Regarding the motor had been modified after July 2011, you don't realize it has been improved from appearance, due to the motor supplier just improved the welding technology on the integrated circuit board as the red circled photos

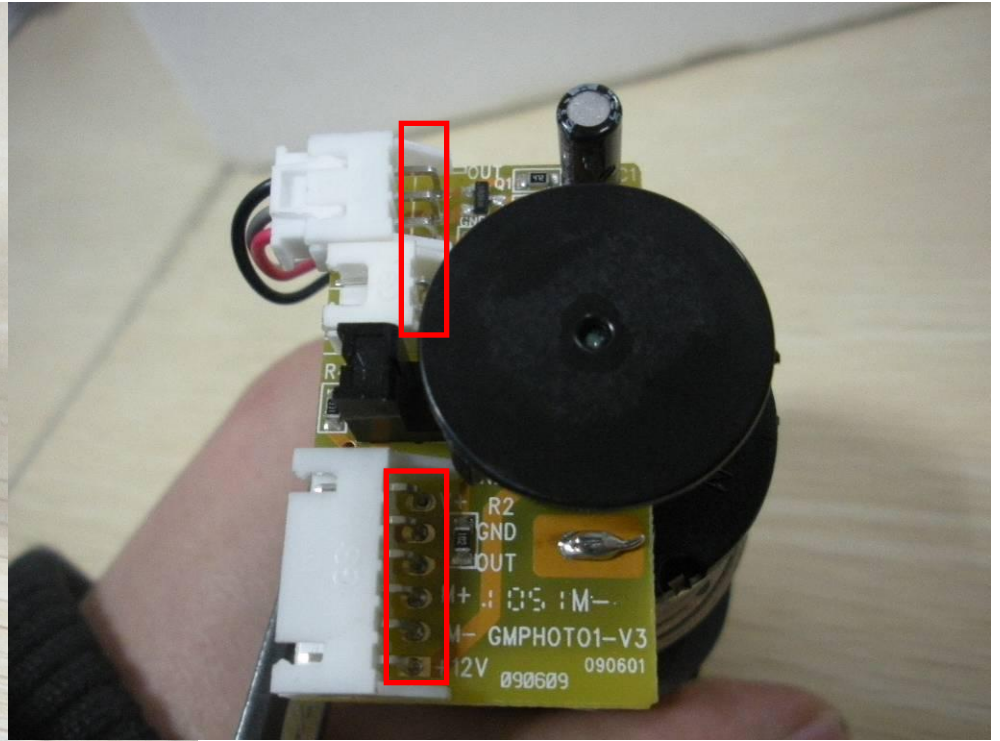
If the limited screw could be loose on the limit ring before shipment, it caused to sleeve screw out of threaded rod

The integrated circuit board could be shake up and down when motor keep driving, so it could cause the count disk to hit the sensor to destroy .At that moment the motor would be scratched itself to create grinding noise. As for this defect, motor supplier added extra 3 screws to fix the integrated circuit board as the following photos show

Factory made this modification on 18th Jan,2012. the first production PO is# 207,the serial number is YFUS-LARGO2-12010001 to YFUS-LARGO2-12010001
